Pearl Place Buildings 1 & 2

**Developer
Avesta Pearl Street One L.P.**

ADDENDUM I

September 15, 2006

DRAWING TITLE: REVISED PAVEMENT STRIPING
(ADDENDUM I)

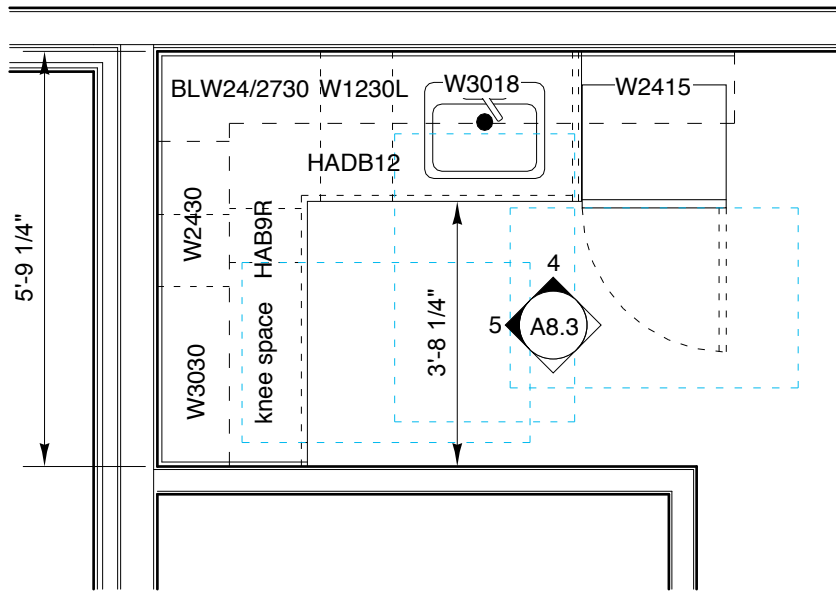
L-2.0/L-2.1 1. Revise Pavement Striping (at Center Parking Island) See L-SK-1 for new plan

8 KITCHEN PLAN

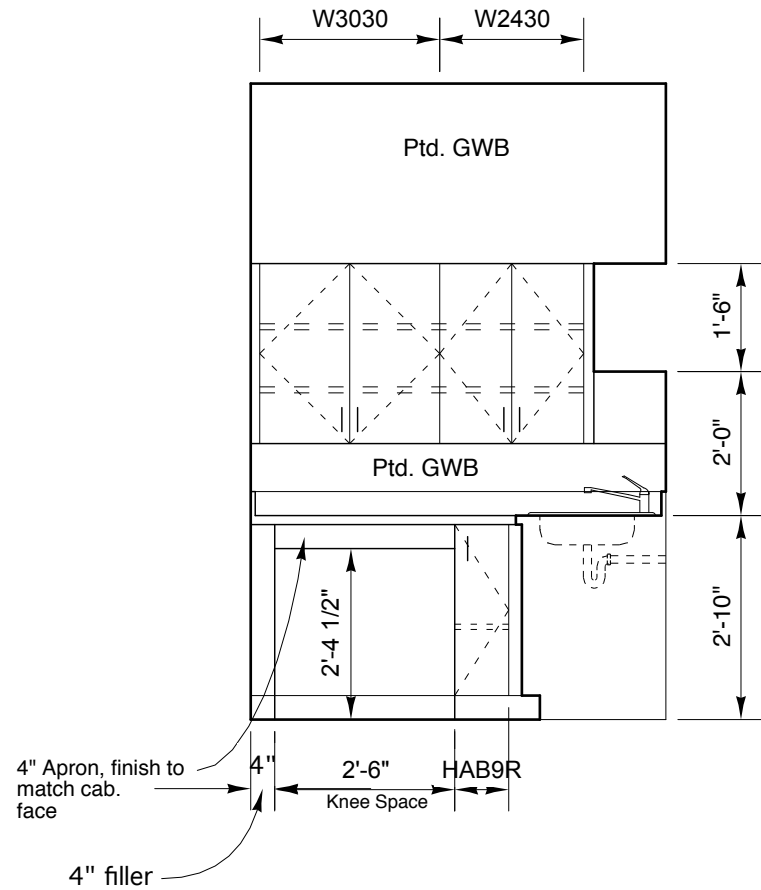
- A8.1** 1. Revised Kitchen Plan 8 is shown on ASK 1.

5 KITCHEN ELEVATION

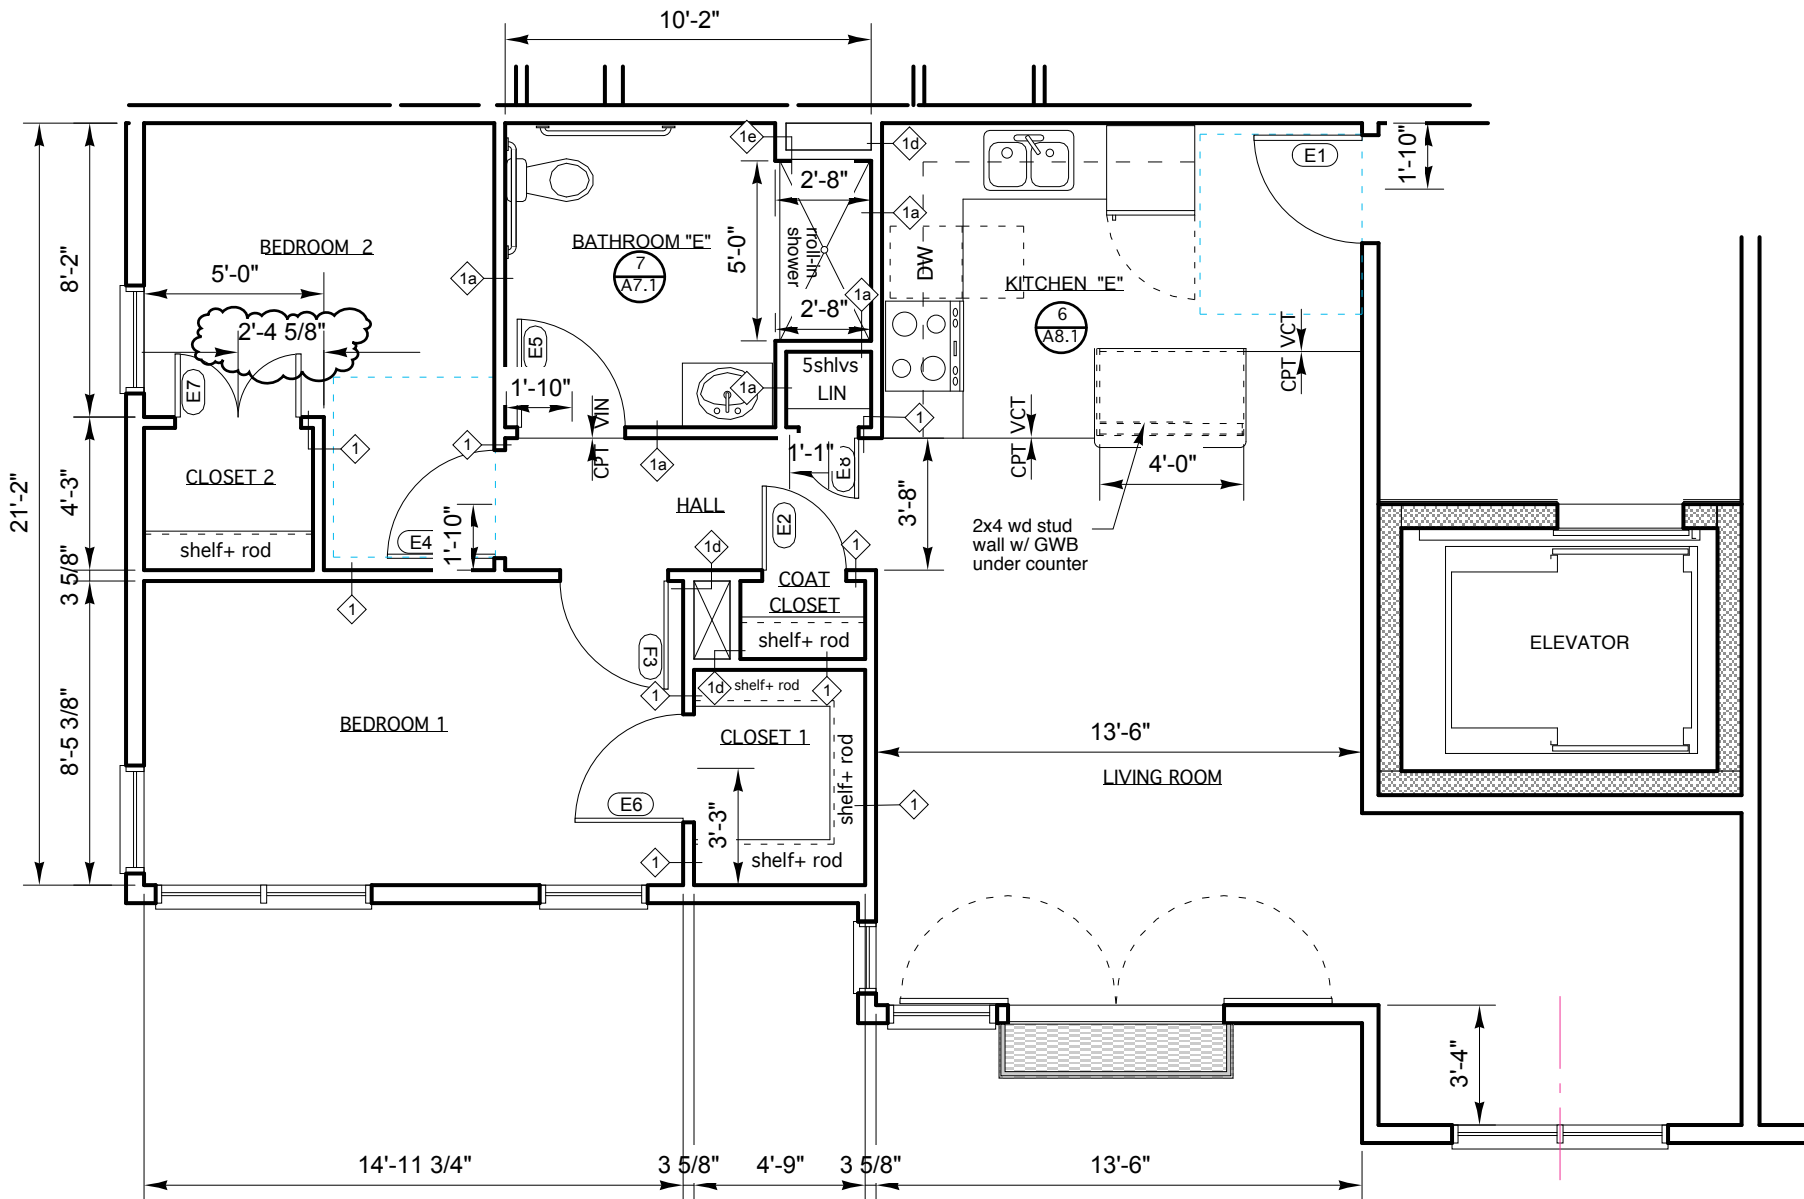
- A8.3** 1. Revised Kitchen Elevation 5 is shown on ASK 1.

REF DWG S1.3

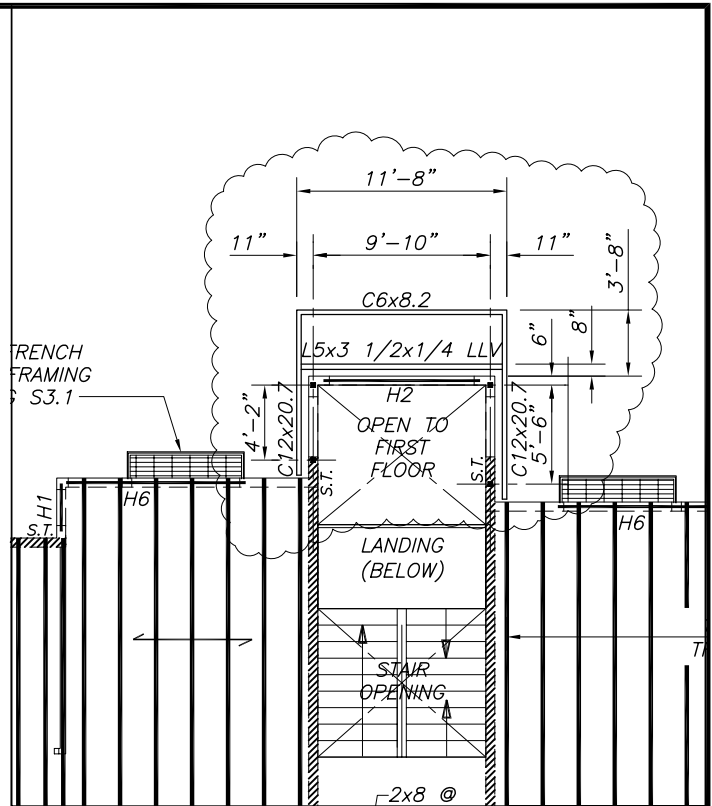
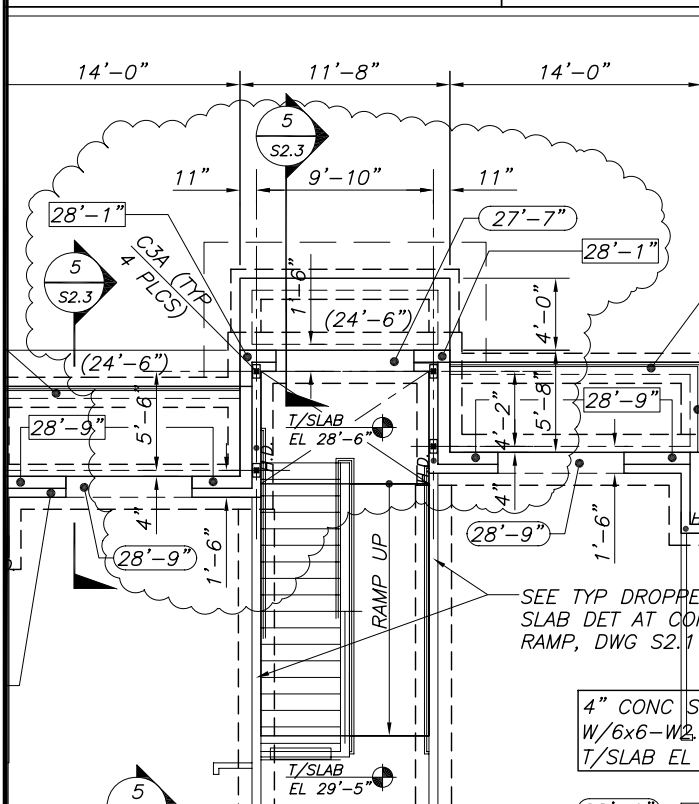
1. Change Note 3 to read: “ Floor Trusses to be designed using dead loads and floor live loads as specified on Dwg. S1.0, General Notes. Coordinate location of specific live loads with architectural drawings.”
2. Add note in plan at jamb in building corner between a H6 header and a H1 header: “ For jamb at building corner, between H6 and H1, follow header schedule for H6 only, with (1) 2x6 jack stud for H1 support, typical.”
3. In Header Schedule, add note to Mark H1: “Jamb typical except at exterior building corners near balcony location, see plan”
4. In Header Schedule, add note at Mark H5: “At attachment of LVL to PSL post, bear LVL on PSL full depth. Provide PSL above and below LVL for continuous load transfer. Attach full height 2x6 on each side of PSL post.”
5. In Header Schedule, change jamb at Mark H6 to “5 ¼” x 5 ¼” PSL/VSL post, typical all levels”.

6. In Header Schedule, modify size at Mark H6 to “3 ½ x 9 ¼ LVL (3 ½ x 11 ¼ LVL at snow drift locations, see plan).
7. In Header Schedule, add note at Mark H6: “ Provide Simpson HUCQ410-SDS (HUCQ412-SDS at 11 ¼” deep LVL) to 5 ¼” x 5 ¼” PSL. Follow manufacturer’s nailing requirements, typical each end.
8. Remove “H1” header designation at both side walls of stair tower at Stair 1-1 & Stair 1-2.
9. Change header designation at front wall of stair towers at Stair 1-1 & Stair 1-2 from “H3” to “H2”.

REF DWG S1.2

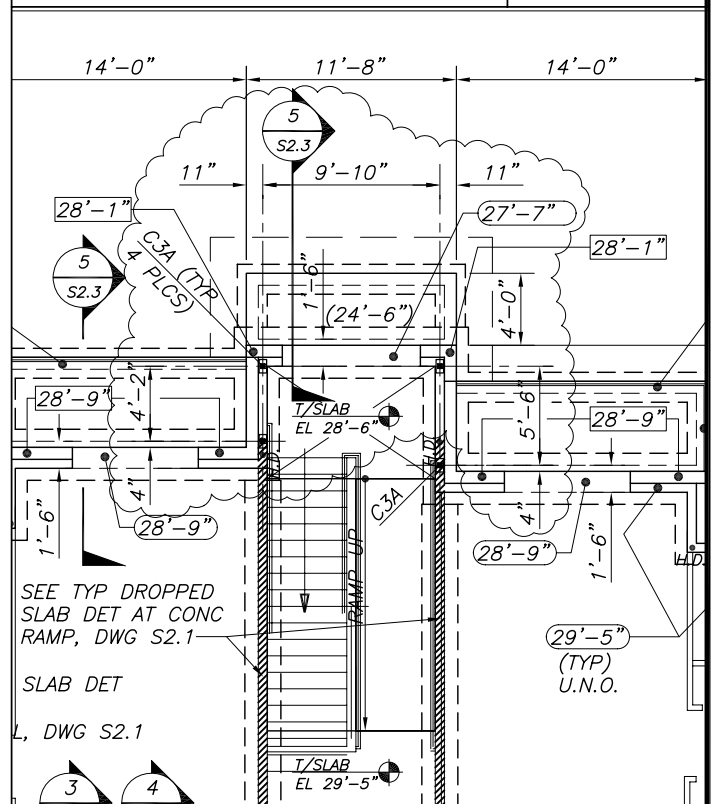
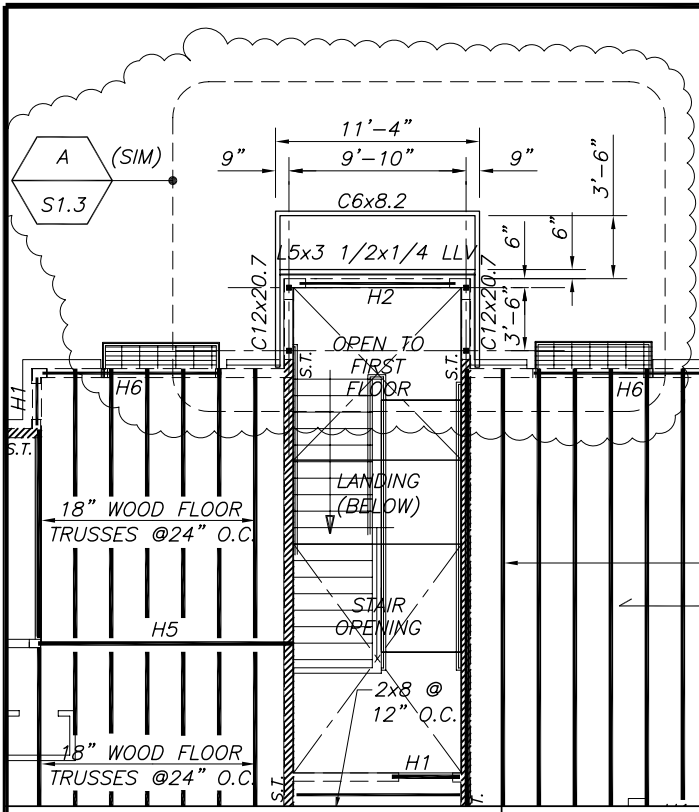
1. At North Wall, change top of brick-shelf elevation from 24’-1” to 24’-9”.
2. At Concrete wall adjacent to parking on Line 7, add note: “Provide 42” x 30” penetration in wall for Mechanical Exhaust Louver. Provide (2)-#8 all around penetration, extending bars 3’-4” beyond opening, typical. Top of Opening = (+26’-7”).”

REF DWG S1.6

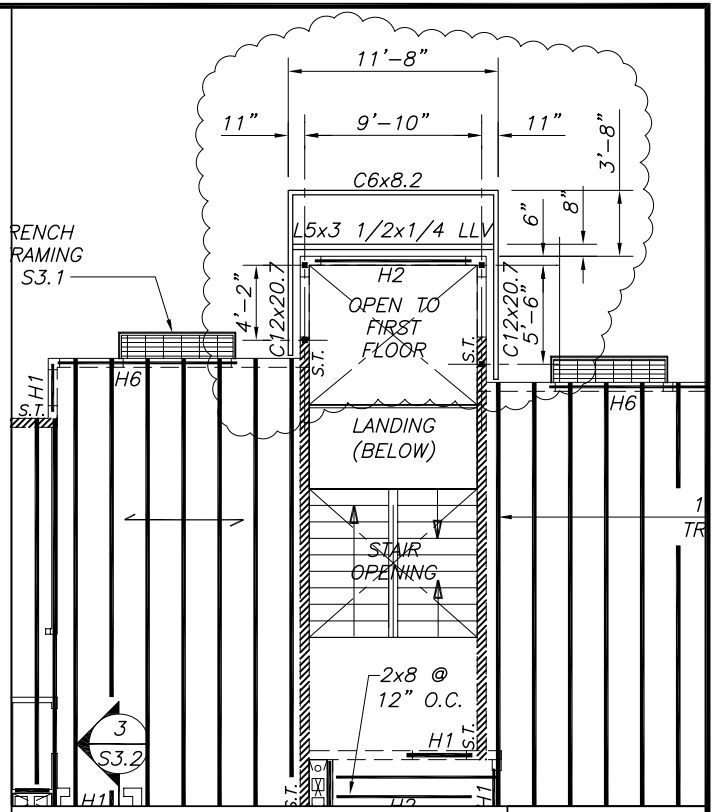
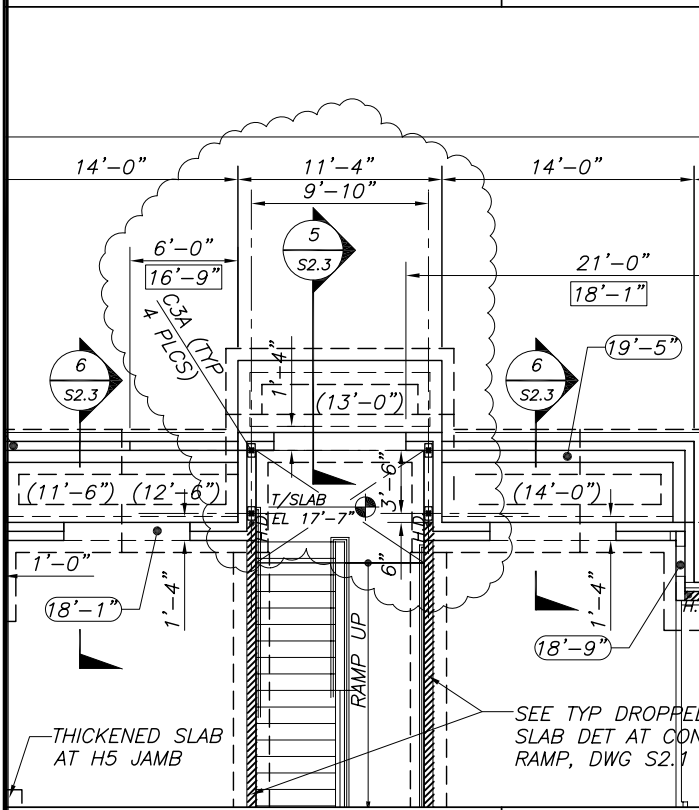
1. Change Note 3 to read: “ Floor Trusses to be designed using dead loads and floor live loads as specified on Dwg. S1.0, General Notes. Coordinate location of specific live loads with architectural drawings.”

2. In Header Schedule, add note to Mark H1: “Jamb typical except at exterior building corners near balcony location, see plan”
3. In Header Schedule, add note at Mark H5: “At attachment of LVL to PSL post, bear LVL on PSL full depth. Provide PSL above and below LVL for continuous load transfer. Attach full height 2x6 on each side of PSL post.”

4. In Header Schedule, change jamb at Mark H6 to “5 ¼” x 5 ¼” PSL/VSL post, typical all levels”.
5. In Header Schedule, modify size at Mark H6 to “3 ½ x 9 ¼ LVL (3 ½ x 11 ¼ LVL at snow drift locations, see plan).

6. In Header Schedule, change note at Mark H6: “ Provide Simpson HUCQ410-SDS (HUCQ412-SDS at 11 ¼” deep LVL) to 5 ¼” x 5 ¼” PSL. Follow manufacturer’s nailing requirements, typical each end.

7. Add note in plan at jamb in building corner between a H6 header and a H1 header: “ For jamb at building corner, between H6 and H1, follow header schedule for H6 only, with (1) 2x6 jack stud for H1 support, typical.”

8. Remove “H1” header designation at both side walls of stair tower at Stair 2-1 & Stair 2-2.

9. Change header designation at front wall of stair tower at Stair 2-2 from “H3” to “H2”.
